DEVIATION REQUEST AND DECISION FORM

Project Name :	GRANDVIEW PHASE 2 (PUDSP-23-006)
Schedule No.(s) :	4200000475, 4200000474
Legal Description :	A TRACT OF LAND BEING A PORTION SECTION 21, AND A PORTION OF THE NORTHEAST QUARTER OF SECTION 28, TOWNSHIP 12 SOUTH, RANGE 64 WEST OF THE 6TH/ PRINCIPAL MERIDIAN, EL PASO COUNTY, COLORADO

A deviation from the standards of or in Section **2.3.8.A** of the Engineering Criteria Manual (ECM) is requested.

Proposed alternative cross section below:

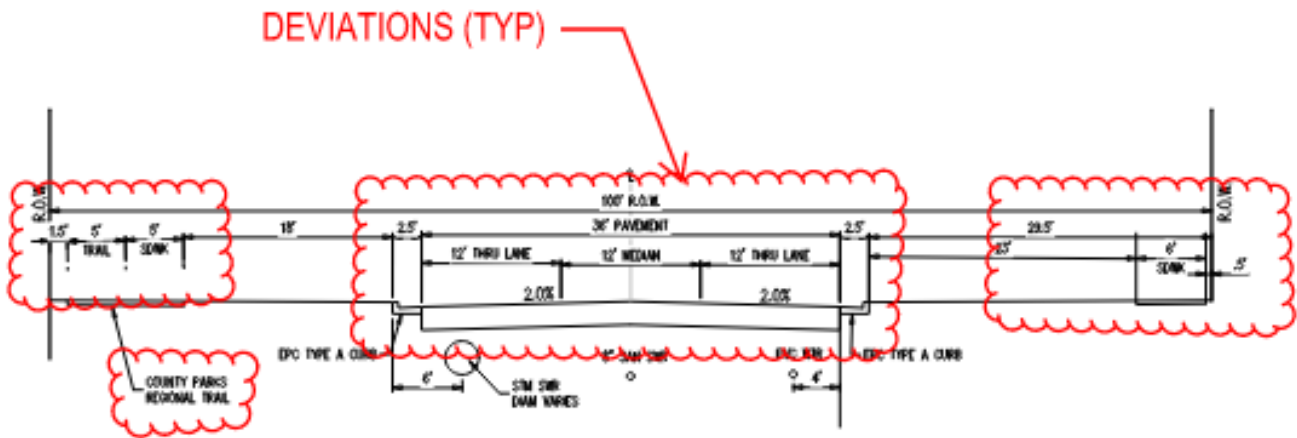
Figure 2-16. Typical Urban Minor Arterial Section. The figure shows the typical cross section with a pavement width of 62' and a tree lawn of 7'. The Modified Urban Minor Arterial Section ((2 Lane) proposes a pavement width of 36' and tree lawn widths of 18' and 23' but maintains the 100' R.O.W.

Explain the proposed alternative and compare to the ECM standards (May provide applicable regional or national standards used as basis):

Figure 23. 2045 Lane Requirements

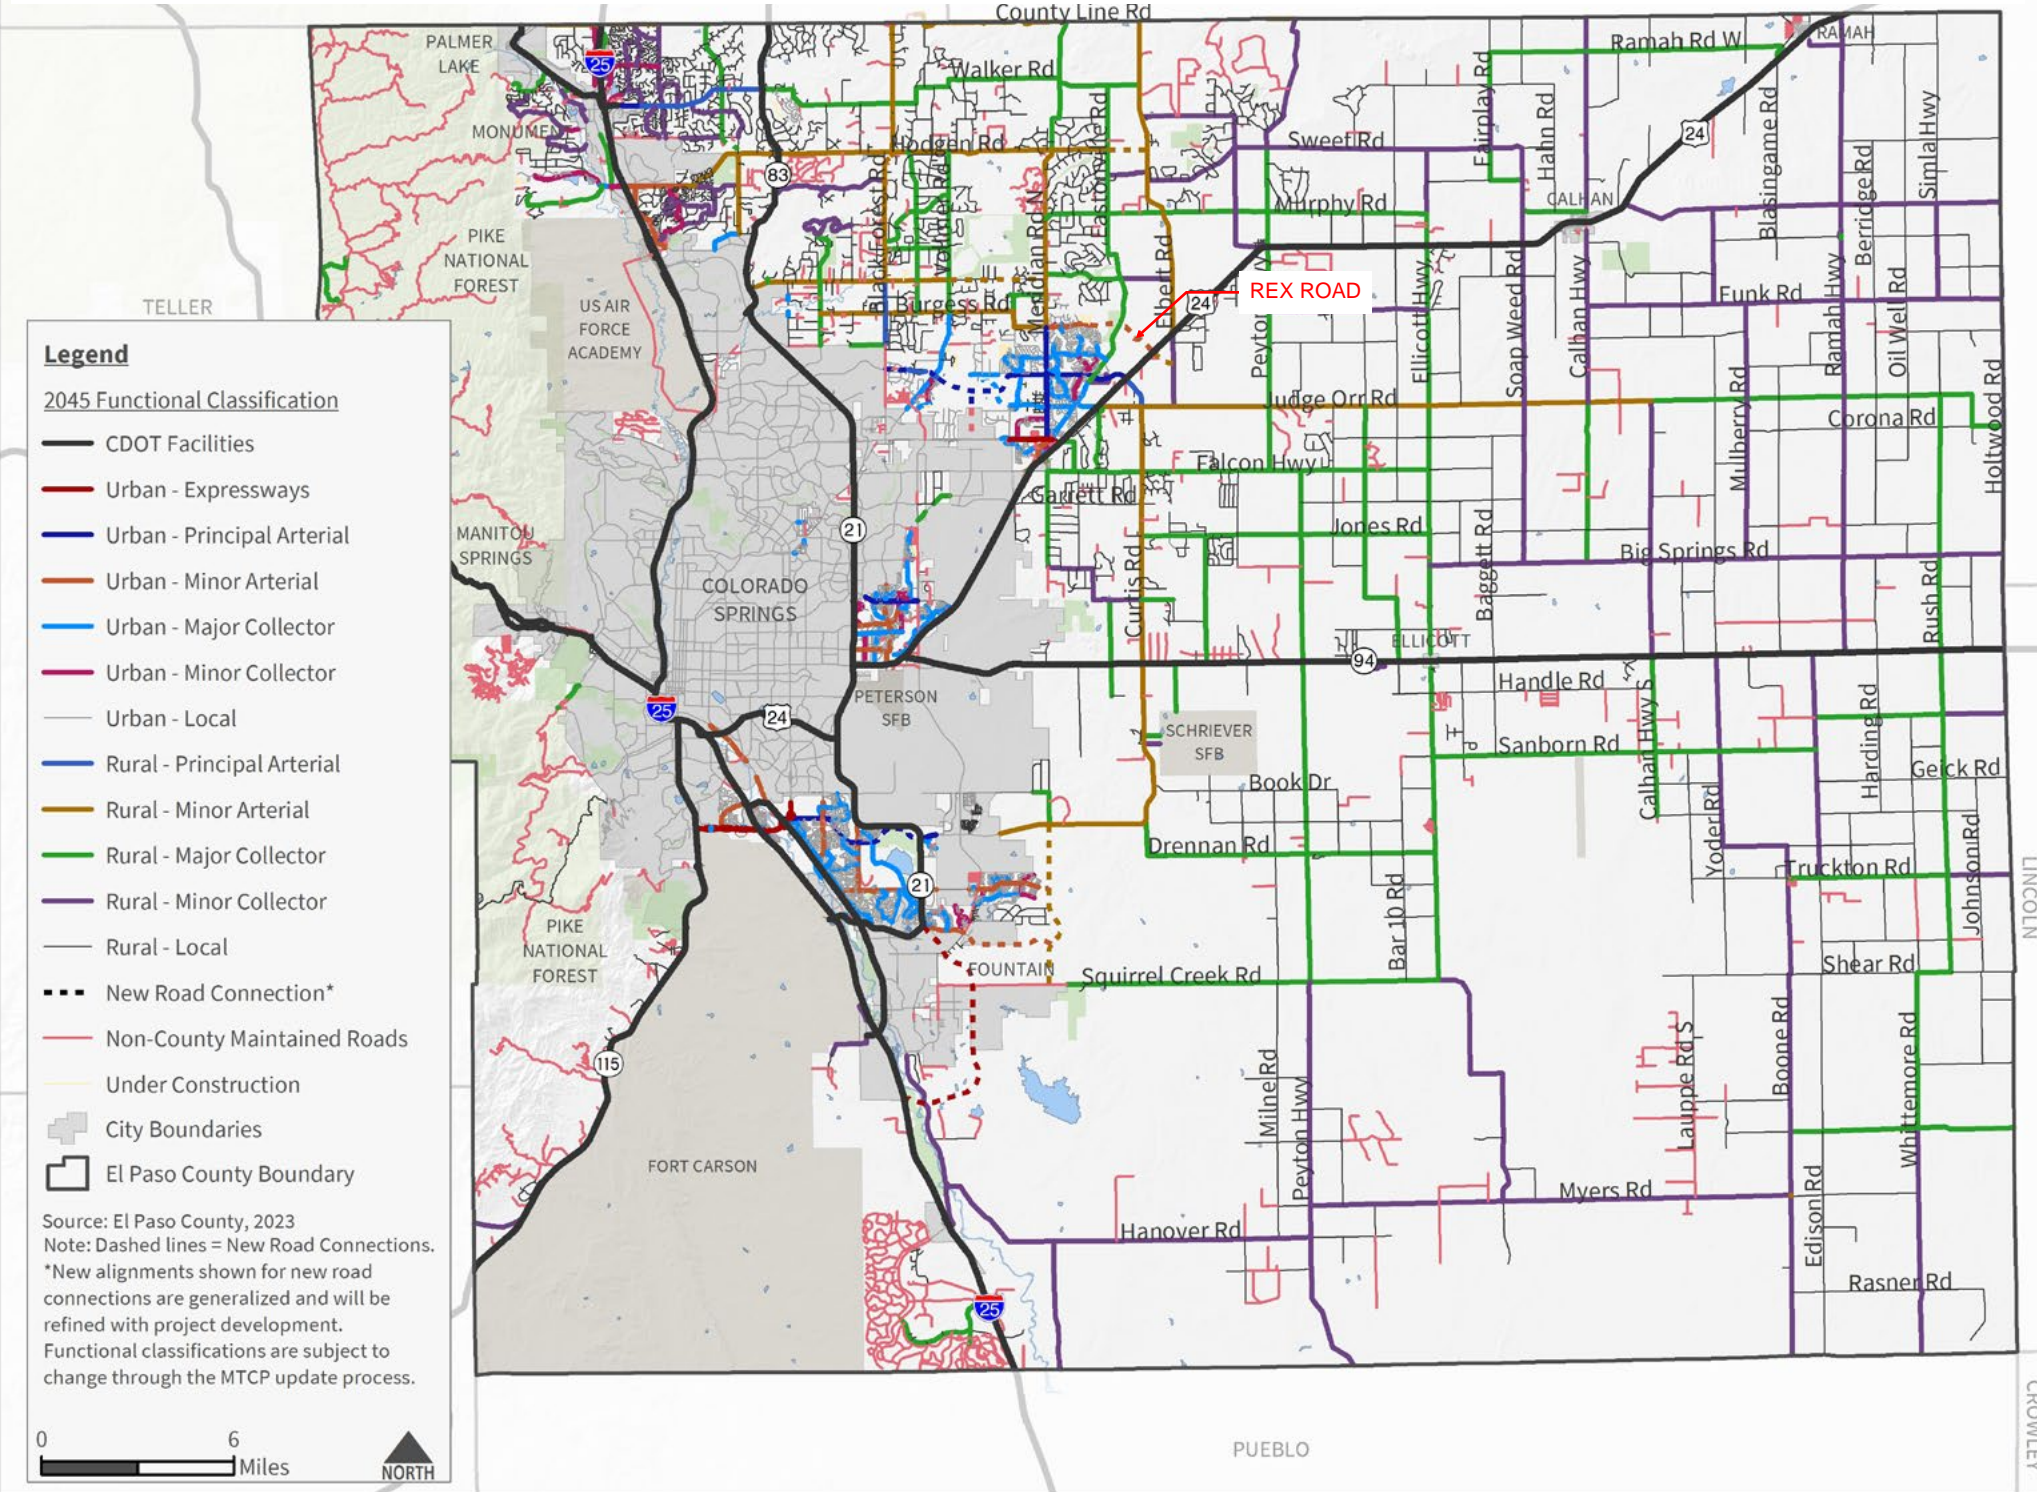
The 2-lane section is consistent with the County MTCP (adopted 2024-07-18) Which identifies the road as an Urban Minor Arterial (2 lane) (See Snips from MTCP below)
